**MOUNTAINSIDE WOODS – SUBDIVISION PUBLIC HEARING (CONTINUED)**  
**PUBLIC COMMENTS AND RESPONSES**  
**PART II**

On October 25, 2012, the Town of Lloyd Planning Board continued the public hearing on the subdivision for the Mountainside Woods project. The following is a list of the individuals who spoke at that public hearing.

**MOUNTAINSIDE WOODS  
VISTA DRIVE  
TOWN OF LLOYD  
ULSTER COUNTY, NEW YORK**

**EXHIBIT A**

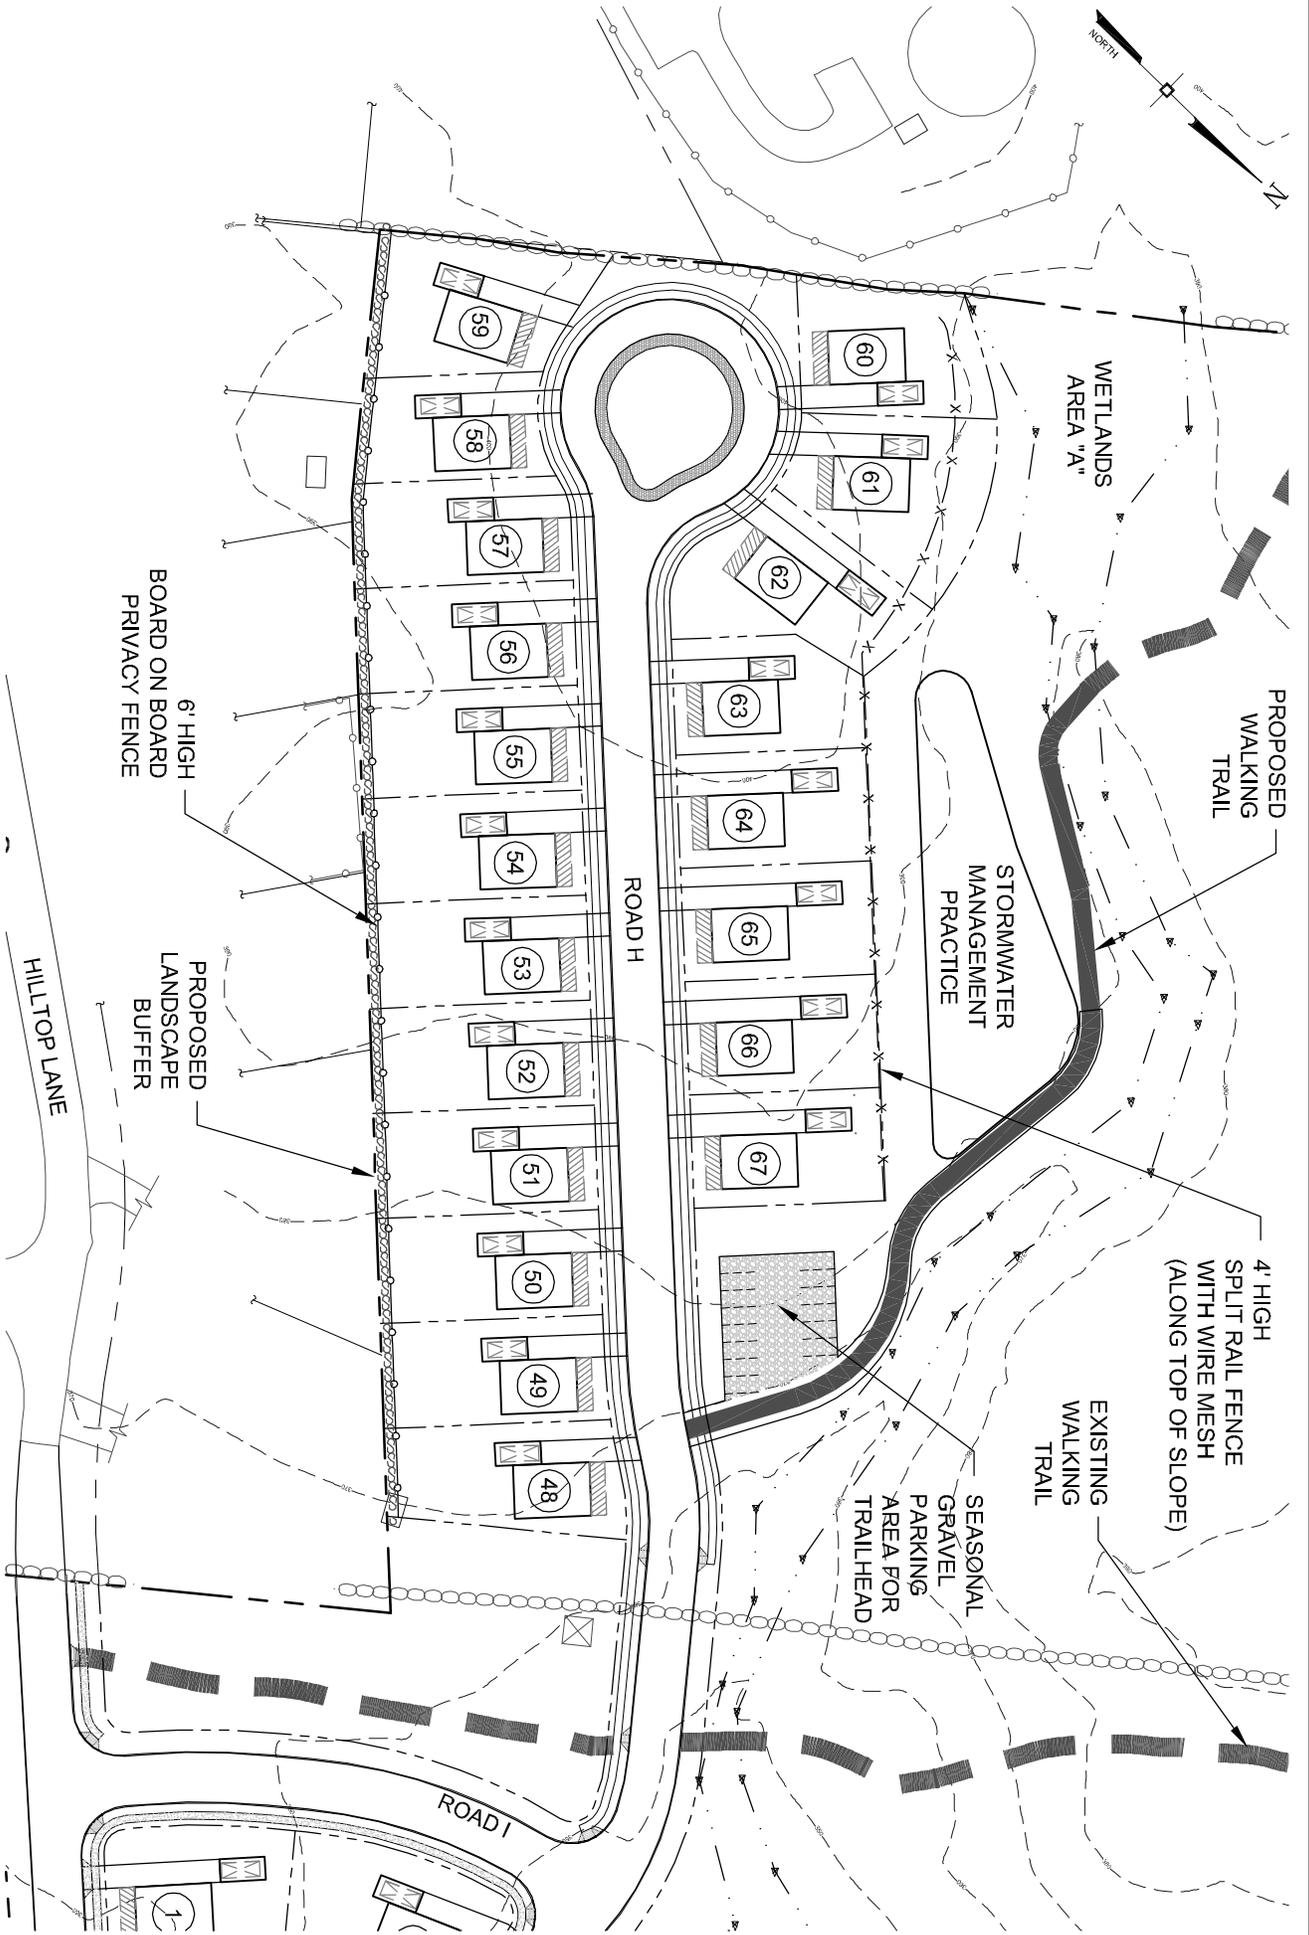
**Comment #37:** Several comments and concerns were raised at both the September and October meetings regarding providing buffering for existing residences including:

- Several residents expressed a desire to see buffering between the proposed homes and the existing residences on Hilltop Lane.
- Thomas Kiss inquired if the homes on the cul-de-sac nearest to Hilltop could be flipped to have fewer homes on the side near Hilltop.
- Frank Sammartano expressed concern regarding the proposed gravel parking area behind his house. He indicated that it cannot be blocked from view by fencing as it is in the Central Hudson right of way.
- Mary Phillips raised a concern about the lack of buffering between the proposed homes and Sunnybrook.

**Response #37:** The applicant has considered all the above comments and offers the following as a comprehensive approach to addressing these issues

First, in the Hilltop Lane area, in order to achieve a greater buffer between the existing homes and the proposed homes on Lots 48 – 57, proposed Road H will be realigned slightly to the northwest which creates deeper lots and allows for more distance between the proposed and existing homes. Moreover, the garages have been moved on proposed Lots 48 to 57 so that they are closer to Road H. These modifications result in a minimum distance of 40' between the shared property line and any proposed home or garage. In addition, the applicant is proposing to construct a 6 foot high board on board privacy fence along the rear of proposed Lots 48 through 59. The fence will be located 5 feet from the shared property line, on the proposed home lots. The finished side of the fence will face the rear of the homes that front Hilltop Lane. The new homeowners will be required to maintain the fence. Evergreen trees (Arborvitaes) will also be planted between the fence and the property line every 10 feet in order to ultimately shield the fence from view. Arborvitaes were selected as they provide a visually appealing landscape buffer yet require little maintenance. Exhibit A, attached, depicts the proposed changes to the plan in this area.

The applicant is also proposing to relocate the seasonal parking area from the eastern side of Road H, near lot 48 and the rear of the home located at 25 Hilltop Lane (the Sammartano property), to the western side of Road H, along the gravel drive which is proposed to service the stormwater pond. The new proposed gravel parking area will accommodate 14 parking spots and will serve as an additional snow storage area, when needed. The relocated parking area is also depicted on Exhibit A. The relocation of this parking area would have made proposed Lot #68 in its current location too narrow as a result this lot has been relocated to an area between proposed Lots 127 and 128 on Road B.

In reconfiguring the area near the existing homes on Hilltop Lane, the applicant examined the possibility of flipping some of the homes to the other side of Road H, however, this would prevent the reconfiguration of the road and relocation of the parking lot. The applicant believes that the proposed modifications best address the issues raised at the public hearings.

**EXHIBIT C**

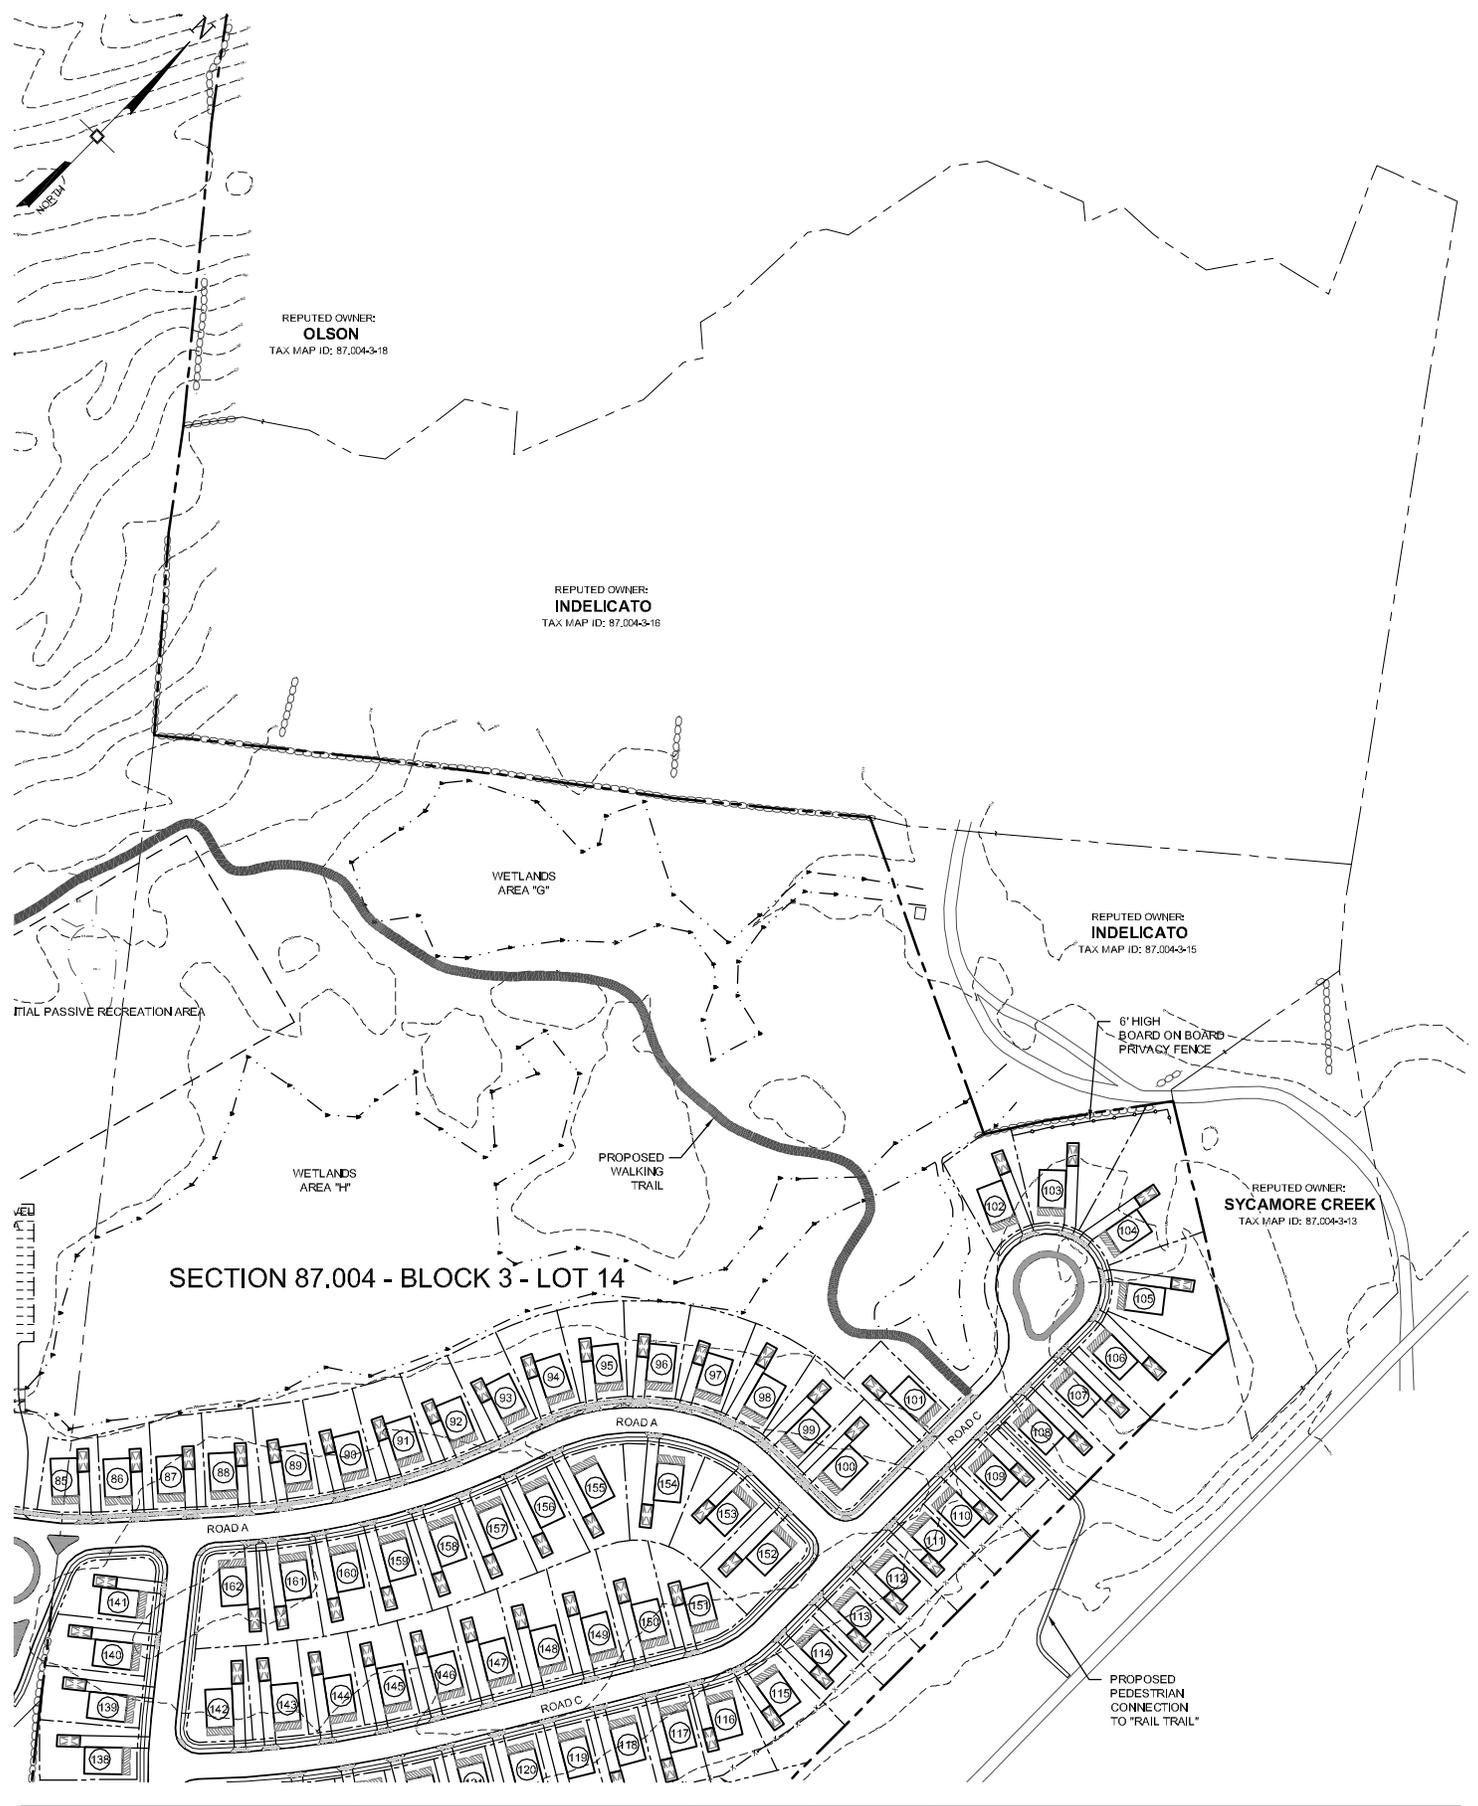
**Comment #38:** John Indelicato: Notes that his property abuts the project on 4 sides and would like to see some buffering: The Planning Board directed the applicant to take another look at providing buffering in this area.

**Response #38:** Attached Exhibit C shows the project with respect to the boundaries of Mr. Indelicato's property. The project site shares four boundary lines with Mr. Indelicato's property, all on the north side of the project. As indicated on the attached exhibit, three of the shared boundaries abut those areas of the site that are proposed as open space. The only proposed development that is near Mr. Indelicato's property is the rear of Lots #102, #103 and #104. The applicant is proposing to install a 6 foot tall board on board privacy fence along the entire length of the rear of lot 103 and along portions of lot 104, as indicated on the attached Exhibit C.

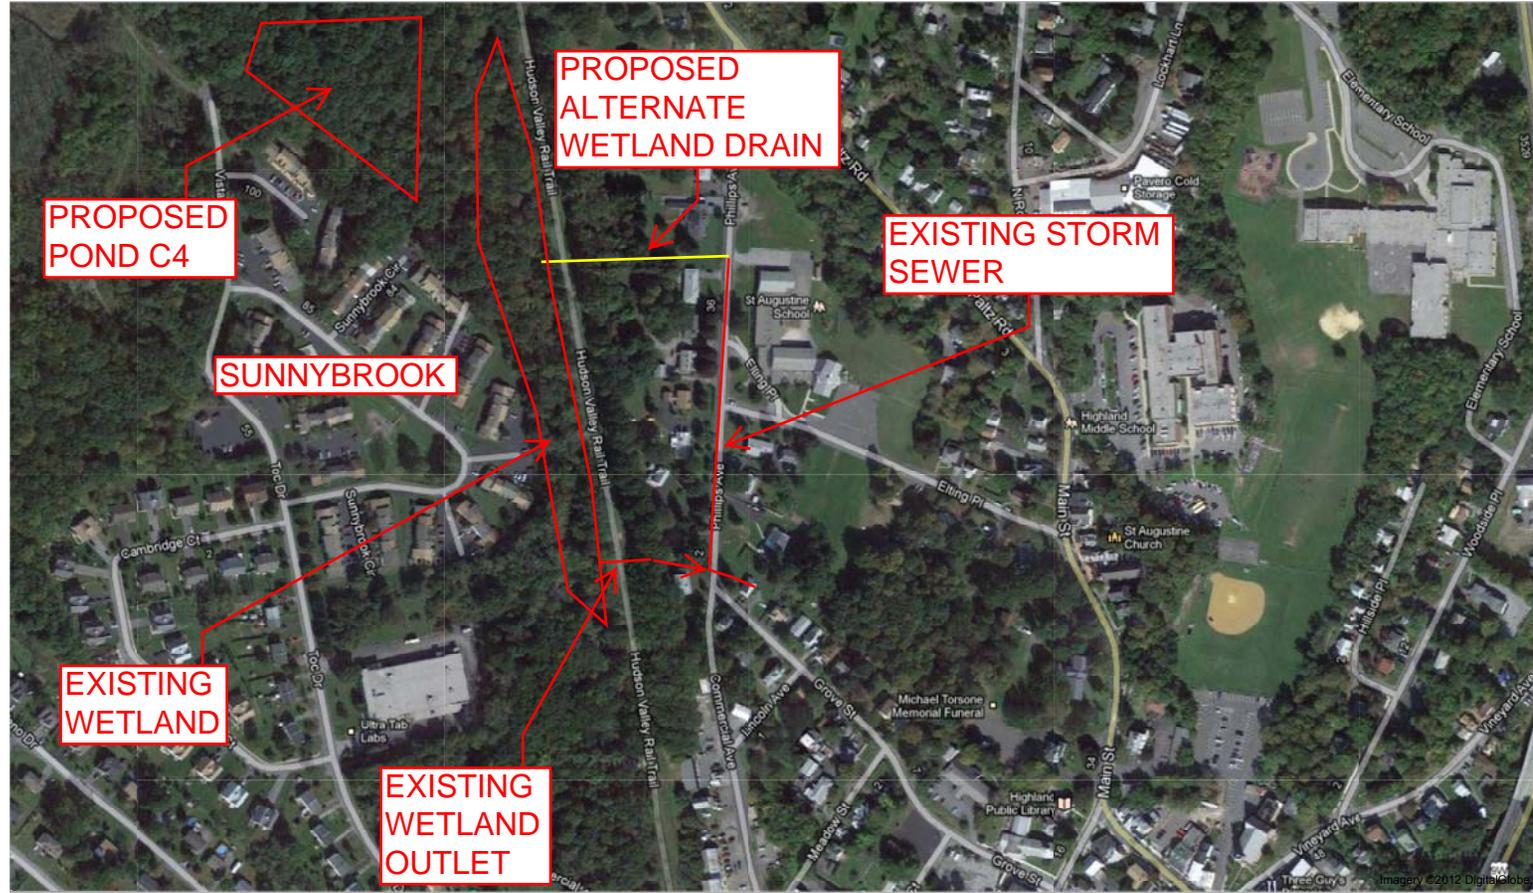
**Comment #44:** John Indelicato: The run-off from the site will be sent to his property and increase his flooding problems.

At the September and October public hearings on the proposed subdivision, Mr. Indelicato commented that his property regularly floods under existing conditions. At the September meeting, he stated "One of my concerns is the stream that comes through this proposed project eventually comes into my property. Last year it washed my lane out three times .... From 2004 up until recently that lane has been washed out at least eight times at the cost of \$5,000 to \$7,000 to repair it. This is the water that comes down from those reservoirs that comes through my property and the stream actually overflows its banks." In response to Mr. Indelicato's comments and concerns, and as was suggested by the Town Board liaison to the Planning Board, Michael Guerriero at the October 25, 2012 meeting, a site walk was conducted at Mr. Indelicato's property. November 2, 2012, the project engineer, Ross Winglovitz, P.E., along with the Planning Board's engineering consultant, Andrew Learn, the Planning Board's planner, Liz Axelson, Planning Board member Carl DiLorenzo, Town Board Member Michael Guerriero and Supervisor Paul Hansut conducted a site visit to examine the current conditions on Mr. Indelicato's property.

### Driveway flooding

Mr. Indelicato showed the group the locations where flood waters have caused damage to his driveway in the past. The primary location of damage was the point at which the unnamed tributary of the Twaalfskill Creek crosses under the driveway through three (3) twenty-four-inch (24") diameter HDPE culverts (photos attached). It appears that flooding in this area may be due to the fact that these culverts are too small to handle the flow from upstream during storms. Another crossing exists on the subdivision site upstream (to the south) of these culverts, which consists of 2 five foot (5') by ten foot (10') box culverts. This existing upstream crossing has an available flow area of approximately 10 times that of the 3 24" culverts located downstream on the Indelicato property.

After flowing under the driveway on the Indelicato property, the stream continues through a low wooded area toward the old railbed that is the base for the Hudson Valley Rail Trail (HVRT). Some natural ponding and wet areas were observed in the downstream area between the driveway and the base of the HVRT.

### Culvert under Rail Trail

An existing 24" diameter reinforced concrete pipe (RCP) currently conveys the unnamed tributary of the Twaalfskill beneath the rail trail. Mr. Indelicato reports that during heavy rains his property frequently floods just upstream of this culvert on this lower part of his property. We observed that this culvert lies at the bottom of an embankment, which is at least 10 feet below the edge of the rail trail. This may provide a large basin area where stormwater may be detained on the upstream (west) side of the culvert. In other words, this basin area may serve to reduce the flow rate of runoff entering the downstream areas of the Twaalfskill. There was discussion of the size of this RCP. It was agreed that any enlargement of this pipe would likely result in higher peak stormwater flows downstream and potentially exacerbate flooding conditions to the east of the HVRT.

The group also visited the area between the HVRT and the existing Sunnybrook development. There was standing water in an existing wet area at this location. The Mountainside Woods subdivision's Pond C4 is proposed to discharge to this wet area. Mr. Indelicato suggested adding a new culvert beneath the HVRT which would drain this existing wetland. This culvert could then tie into the existing stormsewer system in Phillips Road/Commercial Avenue.

We inspected the catchbasins and manholes downstream from the HVRT. It was discovered that the existing stormsewer ties into the same point along Phillips Road/Commercial Avenue as the current wetland discharge point. The suggested modification of adding a new culvert beneath the HVRT to drain the wetland on its southwest side, if implemented, would result in over burdening the existing stormsewer system. The altered path of stormwater would reduce the effectiveness of the detention volume provided by the existing wetlands and could potentially exacerbate downstream flooding conditions.
